## AMA D1 Limited-RID UAS & Geo-Fencing Comment

My name is Andy Argenio and I am writing today not as an Academy of Model Aeronautics (AMA) Executive Board Member but as the Chairperson of AMA's Advanced Flight Systems Committee (AFSC) whose members are deeply concerned with proposals in the FAA's NPRM for Remote-Identification (RID). Specifically, we have safety and utilization issues with FAA's technology choices for Standard and Limited RID and their design and performance requirements for UAS/model-aircraft.

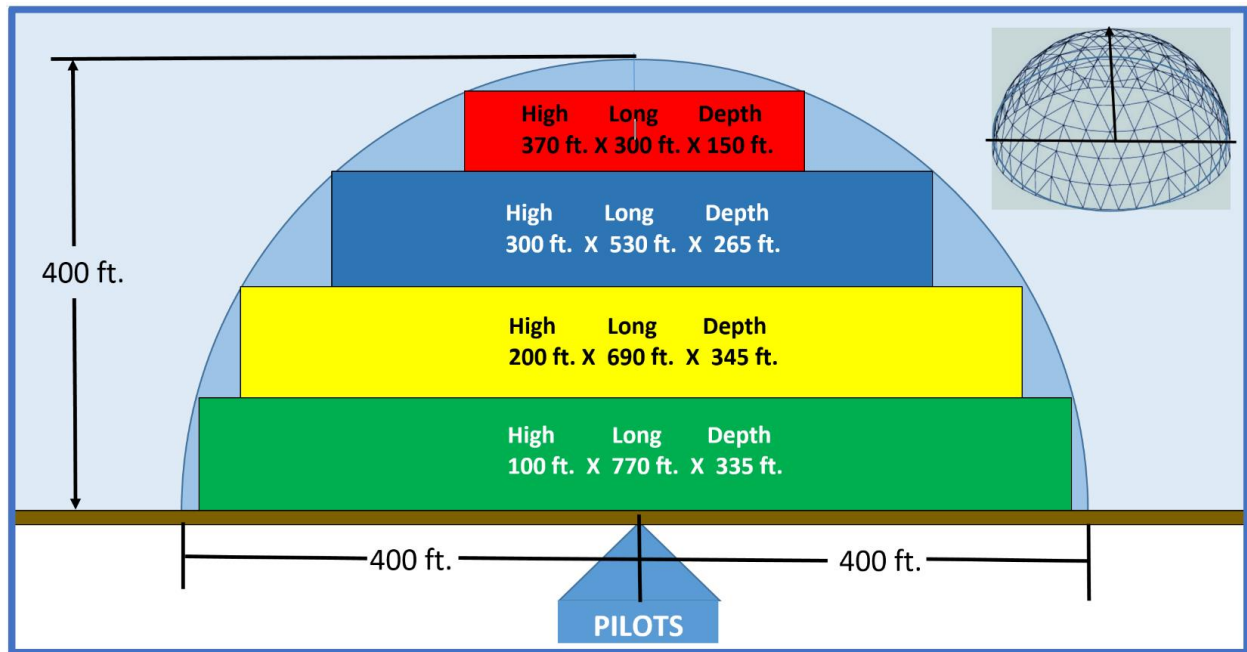
**The Dome shape virtual geo-fenced encapsulation is only suitable for 2 lbs. or under model aircraft because the diameter gets progressively smaller at cruising altitudes**

**At a cruising altitude of 370 ft. the max diameter is 300 ft. and AMA safety rules require no flying behind yourself so the depth is 150 ft. which is unsafe especially for several /more UAS.**

As can be seen in the drawing that follows, an 800 ft. diameter on the ground reduces to a lateral flight distance of 300 ft. when flying at an average altitude of 370 ft. by virtue of the geo-fenced dome shape which progressively reduces the flight area as a model aircraft climbs to its cruising altitude. AMA clubs most often allow four model aircraft to fly at the same time. Since AMA safety rules require operators to fly only forward of a flight line and not in the back of themselves, the area for flying would be reduced to half a dome. The depth at the 370 ft. altitude is now only 150 ft. from the operator. These distances are at their maximum only near the center of the dome shape and reduce as the model aircraft is navigated away from the center and to higher altitudes. The operator would have to navigating a continuous turn within an invisible virtual dome.

**A TYPICAL AMA FLYING SITE CAPABLE OF ACCOMMODATING A VARIETY OF POPULAR MODEL AIRCRAFT FOR RECREATIONAL AND COMPETITION FLYING**

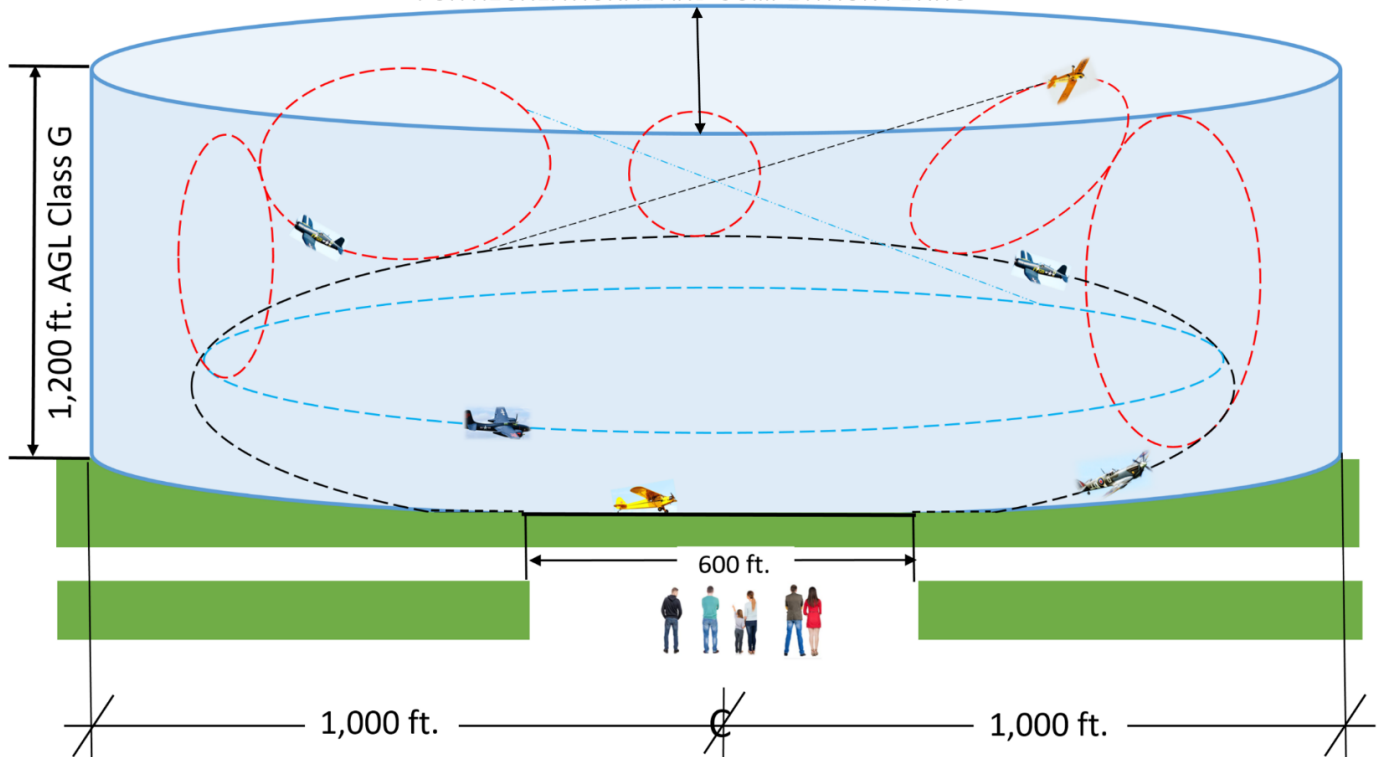
AMA club flying sites and runways are sized to accommodate the wide variety of model-aircraft flown by their members as can be seen in the drawing below. The sites are most often located in rural areas on open and unobstructed fields where members fly three or four model aircraft in a race car track flight path either clockwise or counterclockwise depending on the wind direction. This pattern of flying is followed in order to prevent aircraft from having a head-on collision while all maneuvers are entered into and exited in the direction of travel.

Limited Remote-ID aircraft confined to within a geo-fenced ½ dome-shaped flight area with a radius of 400 ft. could not be safely flown in the prescribed flight path with other model aircraft that are flown at lateral and depth distances limited by the line of site of the operator or club boundaries. Even if the 400 ft. geo-fencing were enlarged for a Limited Remote-ID aircraft it would have to be capable of being deactivated by the operator for emergency situations as described in the previous section. It would also have to allow the operator to alter via his transmitter the turnaround maneuver direction when a model aircraft does a controlled reentry into the permitted flight area after flying beyond a virtual geo-fenced boundary to prevent a head-on collision with oncoming aircraft.
